Colt Industries

Subject: Colt Industries-Fairbanks Morse Engine Division
Colt PC-2 and PC-2.3 Emergency Diesel Generators
Fuel Injection Pump Delivery Valve Holder
Part 21 Report

Subject: Fuel Injection Pump Delivery Valve Holder

FUEL INJECTION PUMP ASSEMBLY

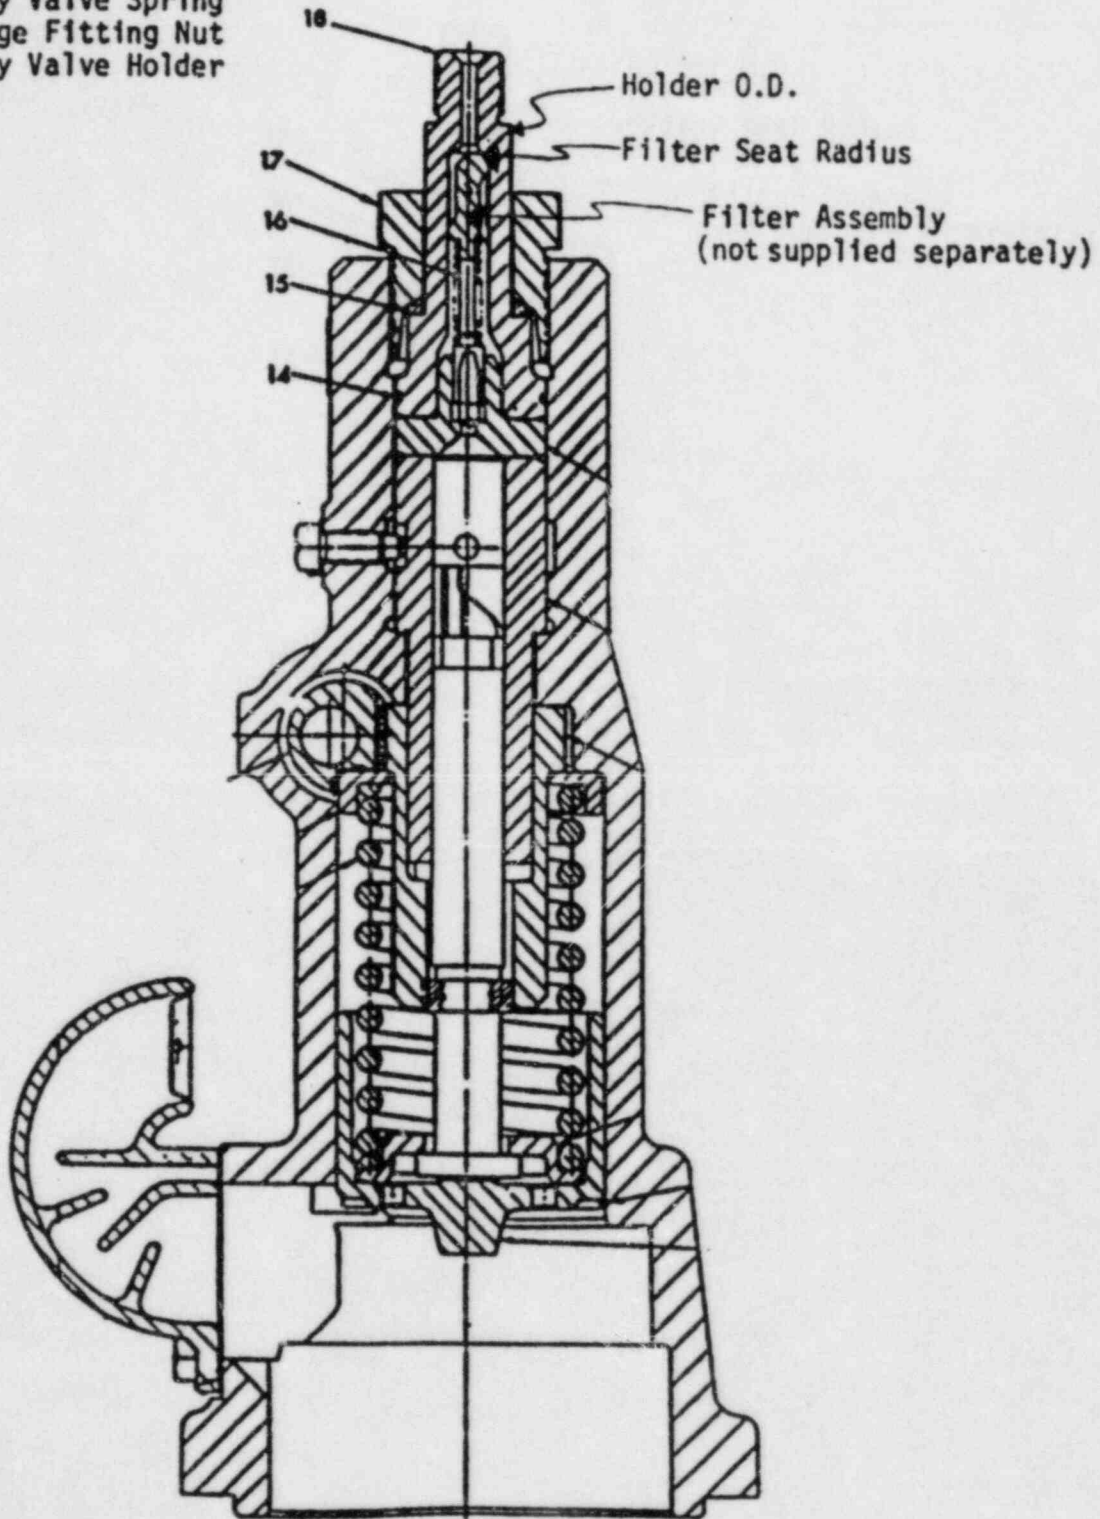
We have become aware of a number of incidents involving the PC2.2, 2.3 and dual fuel engine, where a fatigue crack has occurred in the fuel injection pump delivery valve holder. The crack is initiated at the filter seat radius (shown on attachment) and progresses to the holder O.D. The crack results from an insufficient radius at the filter seat, causing a stress riser at this point. This may result in leakage of fuel oil under high pressure during the injection stroke, creating a potentially dangerous situation.

1. Return all existing delivery valve holder shelf stock (Part No. P12606909) to our Beloit facility for inspection. All holders found with improper radius will be replaced.
2. Holders installed in new or rebuilt pumps after January 27, 1982 should be removed from pumps and returned for processing per No. 1 above.
3. All holders must be removed from pumps on engines built after January 27, 1982 and returned for processing per No. 1 above. A listing of your engines in this category is listed below.
